CITY OF STAR

LAND USE STAFF REPORT

FILE(S) #: PP-22-05 MOD Preliminary Plat Modification for Star River Ranch

PR-24-05 – Private Road Application

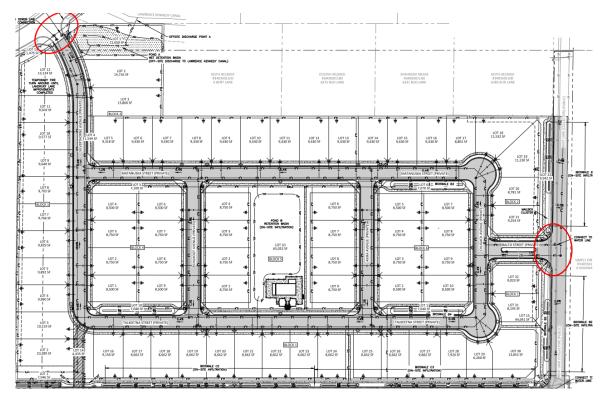
The proposed private streets will include two gates to be located at the development's entrance points. One gate will be placed at the primary entrance road for the subdivision, Balto Street, a full access point connecting to Bent Lane via State Highway 44 (State Street). Balto Street leads into Chugach Avenue which forks north and south into Matanuska and Talkeetna Streets respectively. Silverthorne Avenue, a north-south local road in the westerly part of the project extends stubs to the north where a future collector roadway (Landruff Lane) is planned. The second gate will be placed at the northwest corner of the site, where Silverthorne

Avenue will eventually connect with Landruff Lane. Gate locations have been circled in the figure below. Schematic examples of the kind of gates contemplated for the development are included within this application.
